UNITED STATES OF AMERICA
NUCLEAR REGULATORY COMMISSION

License Amendment Request
No. 98-01

IMPLEMENTATION OF 230 KV SYSTEM IMPROVEMENTS

A. DESCRIPTION OF AMENDMENT REQUEST

FSAR UPDATE
UNITS 1 AND 2
DIABLO CANYON SITE
FIGURE 8.2-1
OFFSITE SINGLE LINE DIAGRAM

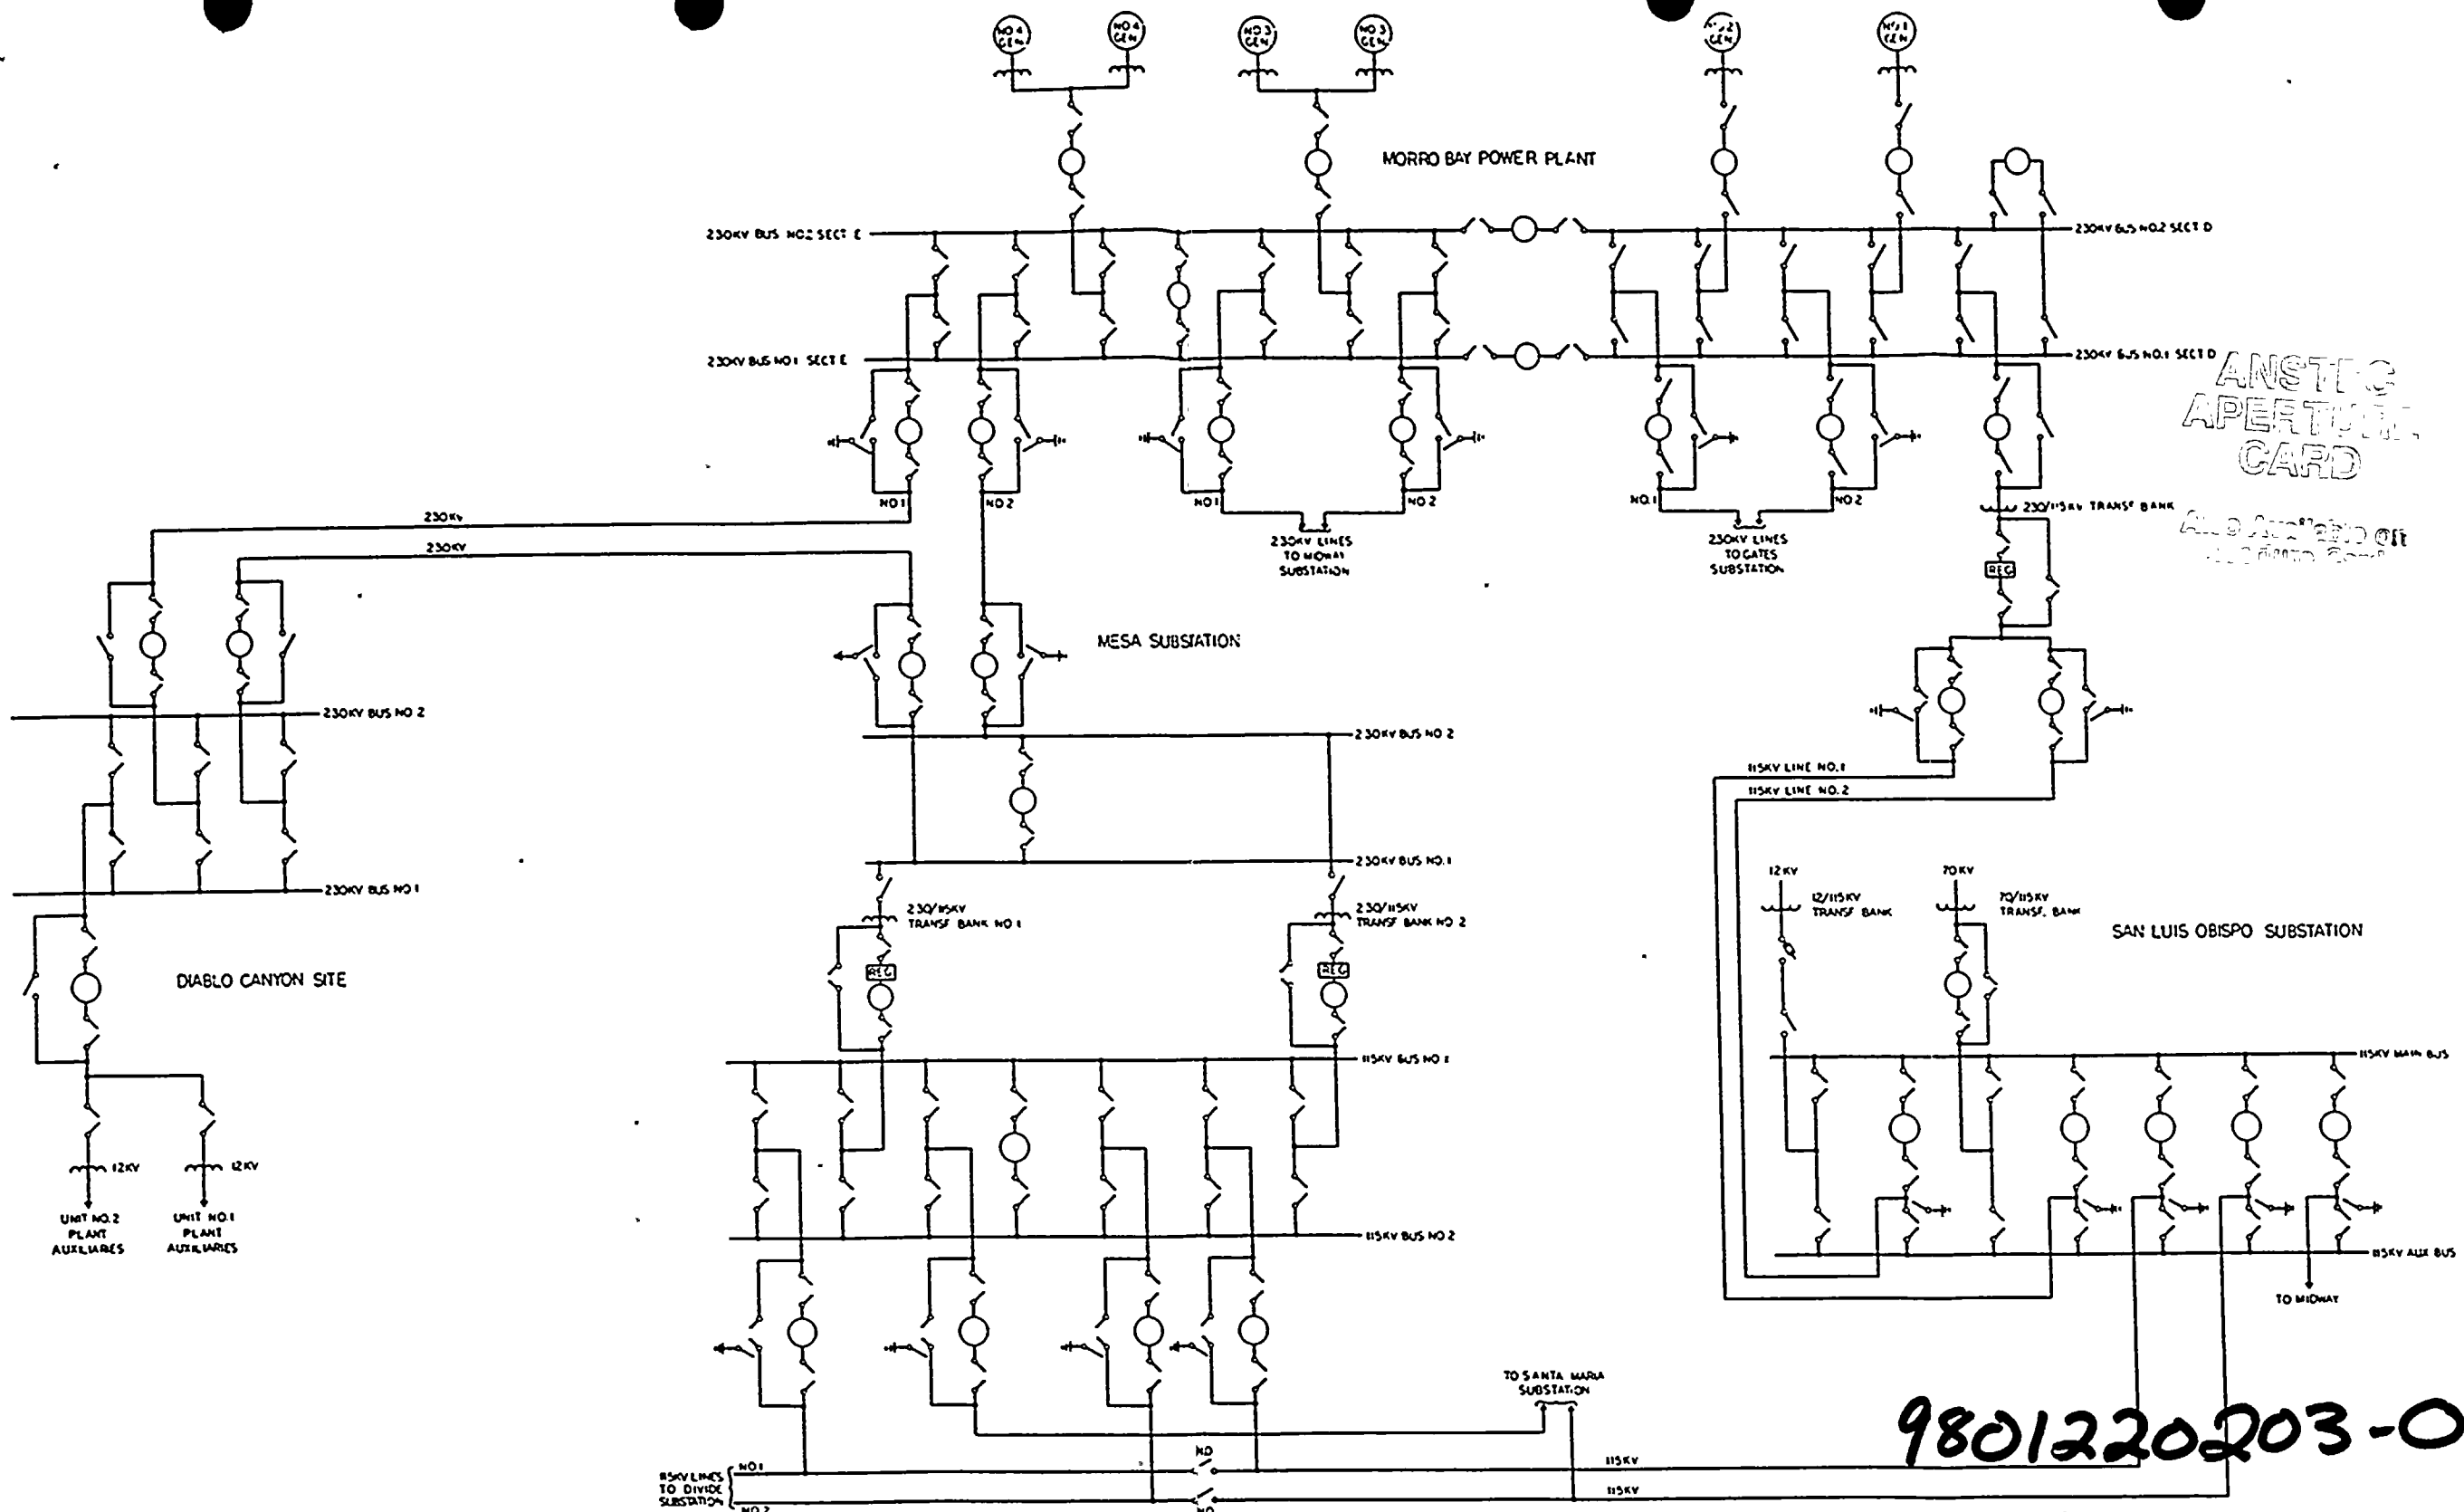
Offsite power (see Figure 1) for startup and standby service is provided from the 230 kV transmission system. The two incoming 230 kV transmission lines, one from the nearby MBPP switchyard, approximately 10 miles away, and the other from the Mesa Substation, feed a 230 kV switchyard having three 230 kV circuit breakers, one for each line and one for the standby startup transformers. Offsite power to the plant auxiliary systems and engineered safety feature (ESF) buses can also be provided from the 500 kV system when the main generator is not in operation. The 500 kV line is a backup for the 230 kV plant power supply via the main transformer to the unit auxiliary transformers.

The 230 kV system improvements include installation of shunt capacitor banks at the DCPD switchyard and at PG&E's Mesa Substation and installation of new 230/12 kV SUTs at DCPD with LTCs. The shunt capacitors will assure adequate VAR support previously provided by MBPP for present peak load and future peak load growth under worst case line outage conditions. Installation of the automatic LTC 230/12 kV SUTs will allow the voltage on the plant 12 kV and 4 kV buses to be maintained within limits acceptable for plant equipment operation given the emergency voltage operating criteria for the transmission system of +5 percent/-10 percent. The normal Western System Coordinating Council (WSCC) voltage criteria for the transmission system of +5 percent/-5 percent is less severe.

PG&E has installed the LTC 230/12 kV SUTs in both Units 1 and 2, although the automatic voltage control feature on the Unit 2 transformer will not be functional until the Unit 2 eighth refueling outage scheduled to begin mid-February 1998. Until the automatic voltage control feature is functional on the Unit 2 SUT, PG&E will manually adjust the tap as necessary to accommodate voltage schedules on the 230 kV system. Tap changes to the new transformer with the LTC can be made on-line without deenergizing the transformer.
